The following is the point-to-point response to all the comments. The page and line numbers in the following response refer to the revised manuscript with changes marked.

Response to Anonymous Referee #2:

Response to Anonymous Referee #3:

Figure S3. Comparison between simulated and measured sediment storage in check dams reported by Fang et al. (2023) ($n=61$). The dashed line indicates the 1:1 line, and the shaded area represents the 95% confidence interval of the fitted regression.”

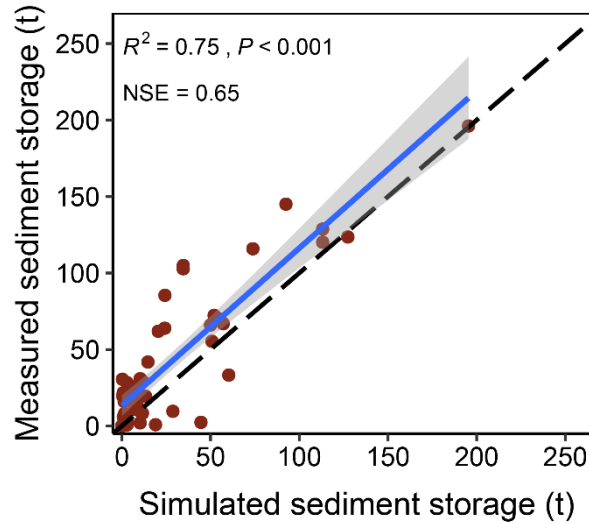
2. The model-performance assessment does not appear to be independent. IC0 and KIC were optimized separately for each of the 17 sub-basins using the observed sediment-yield records, after which the same observations were used to report NSE and R2. These values therefore describe goodness of fit rather than predictive validation.

Reply: We have revised the wording in the manuscript and changed “model validation” to “goodness-of-fit” where appropriate (see Lines 290, 303, 330, and 343).

To provide an additional and more independent evaluation of the sediment trapping module, we further used field-surveyed sediment accumulation data for check dams from Fang et al. (2023) (see Lines 303-305 and 333-334).

"In addition, to independently assess the sediment trapping module, the simulated sediment accumulation was compared with field-surveyed sediment accumulation data from 61 check dams reported by Fang et al. (2023)."

"In addition, the simulated sediment trapping by check dams agreed well with the observations from field survey ($NSE = 0.651$, $R^2 = 0.75$) (Fig. S3)."
